Proposed Modification to Design Basis: Groundwater Discharge Permit No. GW1810162

David List, P.E.
Golder Associates Inc.

Kennecott
Eagle Minerals

Infiltration System: Existing Permitted Design versus Proposed Modified Design

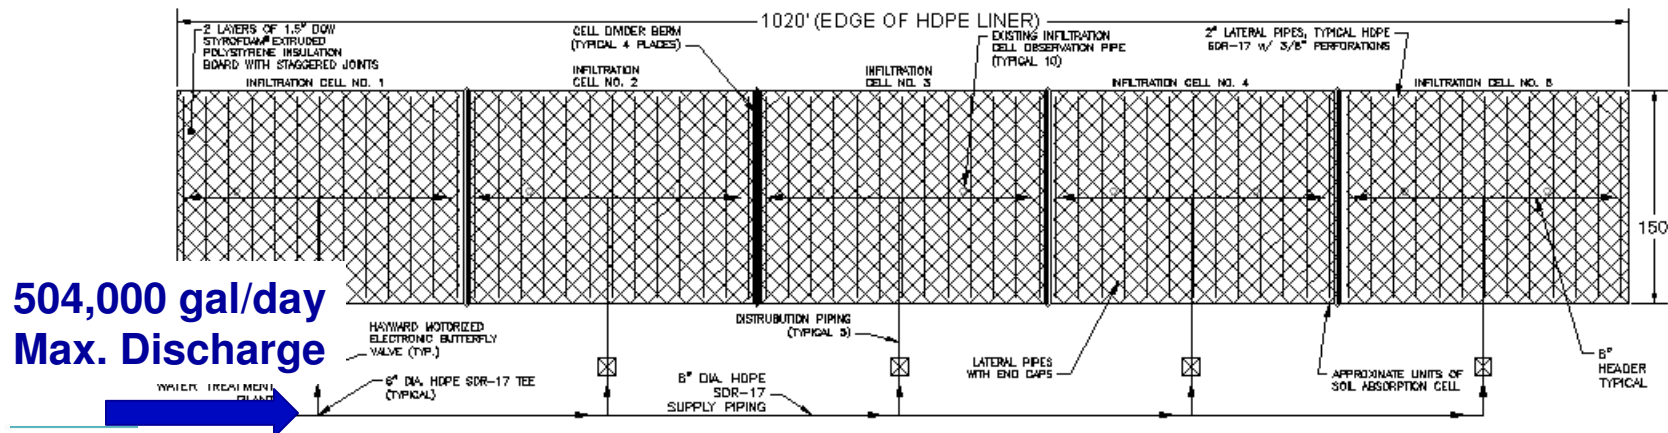
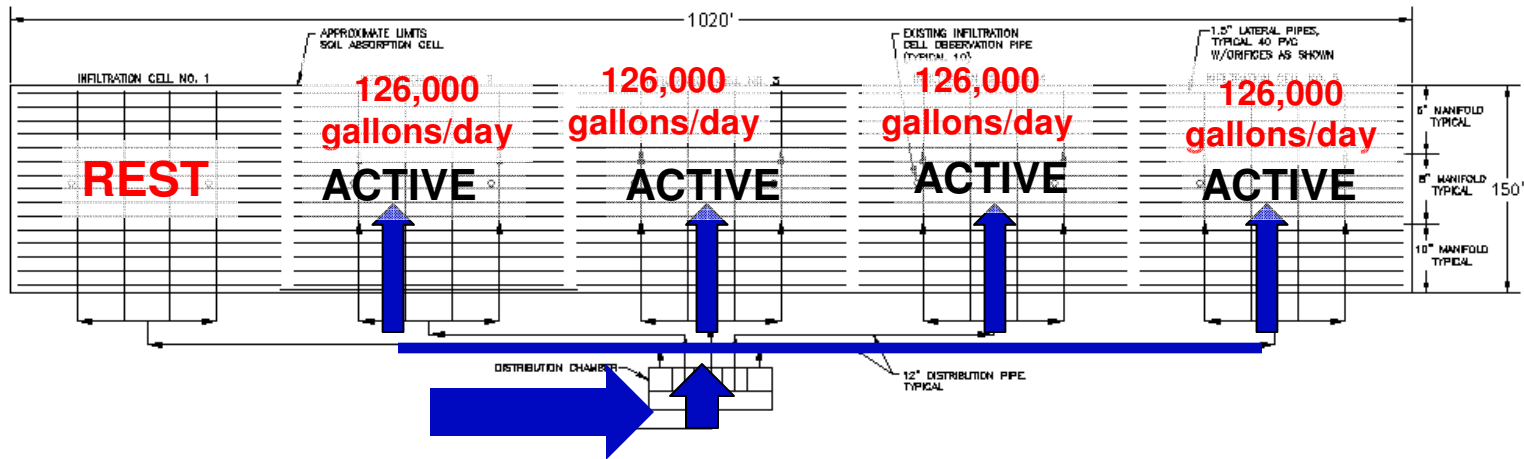
- ❑ Water is delivered to the infiltration system in a slightly different manner namely eliminating the distribution chamber and replacing it with individual valves and flow meters.
- ❑ The diameter of the laterals has been increased from 1.5 inch PVC to 2 inch HDPE.
- ❑ The length of the lateral distribution pipe has been decreased.
- ❑ The cover system has changed from several feet of soil to synthetic insulation overlain by a geomembrane.
